# HISTORIC AND DESIGN REVIEW COMMISSION

**HDRC CASE NO:** 2018-204  
**ADDRESS:** 611 N OLIVE ST  
**LEGAL DESCRIPTION:** NCB 562 BLK 8 LOT N 60 FT OF 16,17,&18 & E 52.08 FT OF W 104.16 FT OF 10 ARB 21  
**ZONING:** R-6, H  
**CITY COUNCIL DIST.:** 2  
**DISTRICT:** Dignowity Hill Historic District  
**APPLICANT:** John Speegle/SKDA  
**OWNER:** Y Designs LLC  
**TYPE OF WORK:** Exterior alterations - Conceptual Approval  
**APPLICATION RECEIVED:** April 26, 2018  
**60-DAY REVIEW:** June 25, 2018  
**REQUEST:**

## Applicant's Project: Residence at 611 North Olive Street

METAL STANDING SEAM  
ROOF

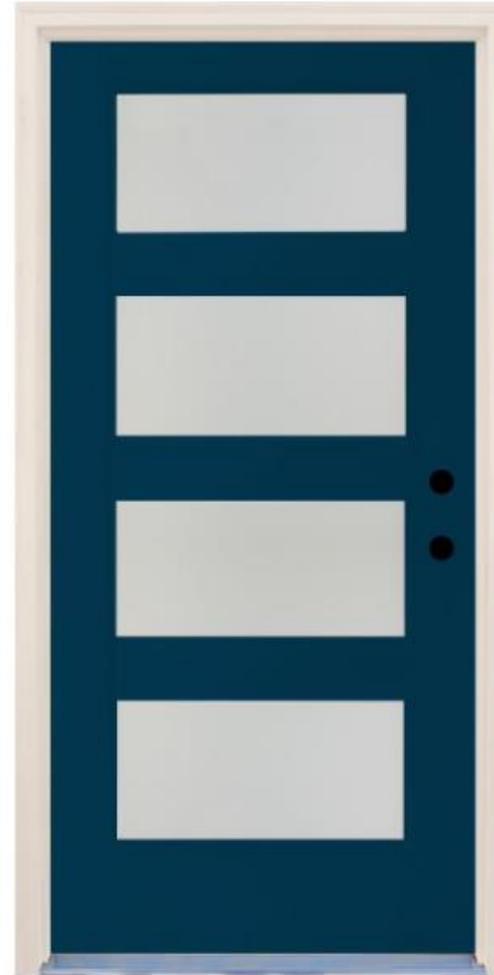
- c. ROOF – The applicant has noted that the existing roof structure is failing. The applicant has proposed to reconstruct the roof structure through the installation of prefabricated trusses. In addition to the reconstruction of the roof structure, the applicant has proposed to replace the built up gravel roof with a standing seam metal roof. Staff finds this replacement to be appropriate; however, the proposed metal roof should feature panels that are 18 to 21 inches in width, seams that are 1 to 2 inches in height, a crimped ridge seam and a standard galvalume finish.

- i. That any original wood siding be repaired in kind.
- ii. That the proposed standing seam metal roof feature panels that are 18 to 21 inches wide, seams that are 1 to 2 inches in height, a crimped ridge seam and a standard galvalume finish.

8" X 8" CEDAR WRAPPED  
COLUMNS

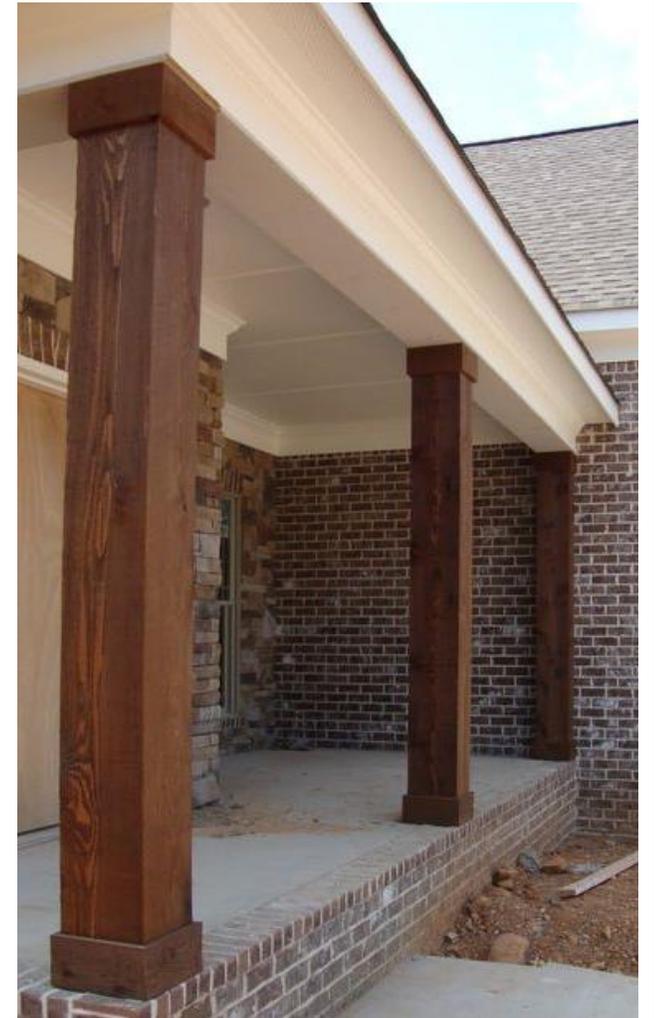
- j. COLUMN REPLACEMENT – The applicant has proposed to replace the existing, brick columns with wood columns. The applicant has noted that the proposed columns will feature an 8x8 profile and will feature cedar. The existing columns feature a more prominent profile than 8x8. Staff finds that a larger profile would be more appropriate than the 8x8 columns given the structures horizontal emphasis.

- iv. That the applicant submit additional information regarding the proposed 8x8 wood columns. As noted by staff in finding j, a column of addition width and depth, comparable to the existing brick columns would be more appropriate than the proposed columns given the length of the front façade and its horizontal emphasis.

SOUTH ELEVATION

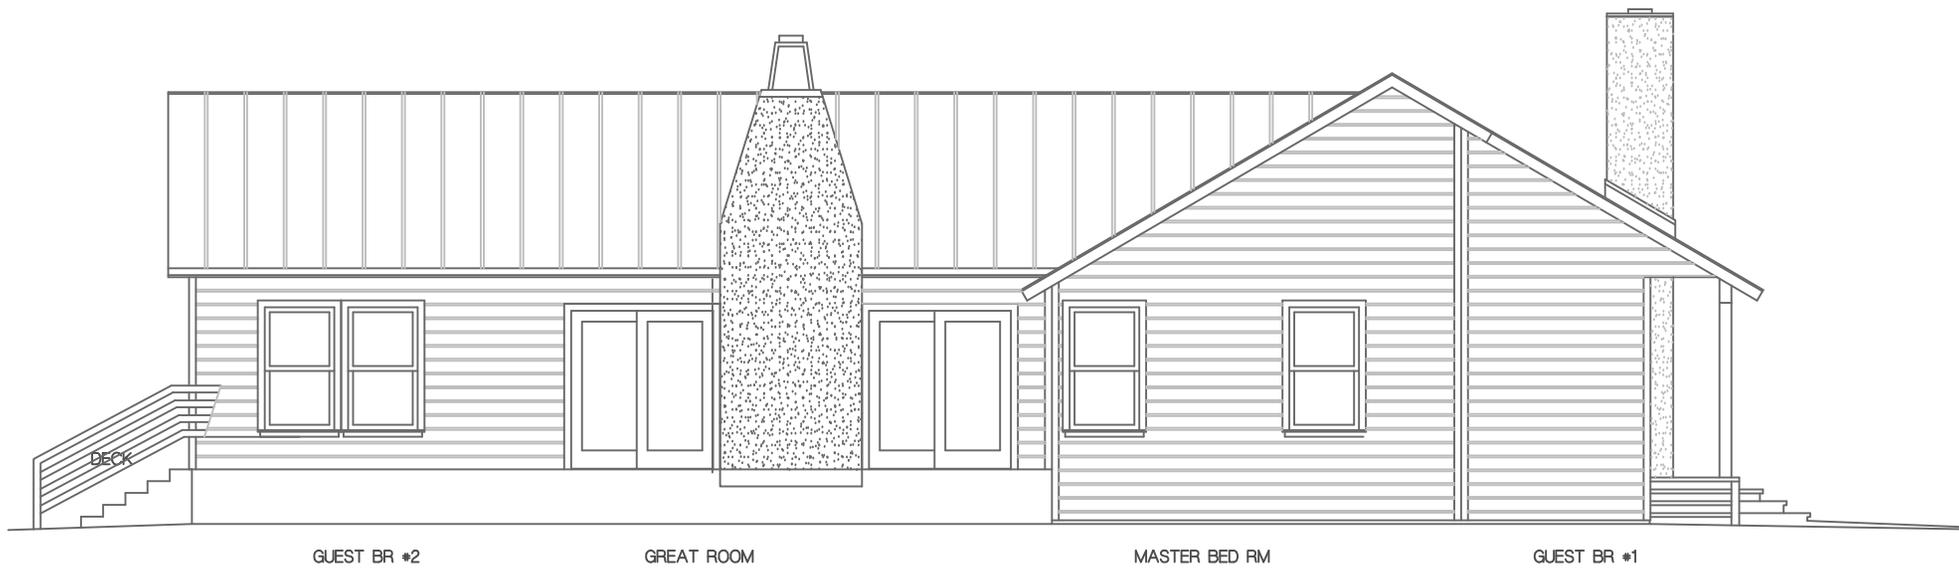
- g. REAR CHIMNEY – The applicant has proposed to construct a chimney on the southern elevation of an existing rear addition. The applicant has noted that the proposed addition will feature a stucco finish. Staff finds the proposed chimney construction to be appropriate.

- h. FENESTRATION MODIFICATIONS – The rear addition currently features two exterior doors and a series of steel casement windows. The applicant has proposed to modify this elevation to feature two, one over one windows and two sliding glass doors on each side of the proposed chimney noted in finding g. The proposed modifications will not be seen from the public right of way. Staff finds these to be appropriate.

- i. FENESTRATION MODIFICATIONS – On the southern façade, the applicant has proposed to remove an existing door that addresses N Olive as well as a side window which faces the side yard (south). While the Guidelines for Exterior Maintenance and Alterations 6.A.i. note that existing window and door openings should be preserved; however, staff finds that the removal of the noted door and window will not be detrimental to the architectural integrity of this structure nor that of the Dignowity Hill Historic District. Staff finds the proposed removal to be appropriate.
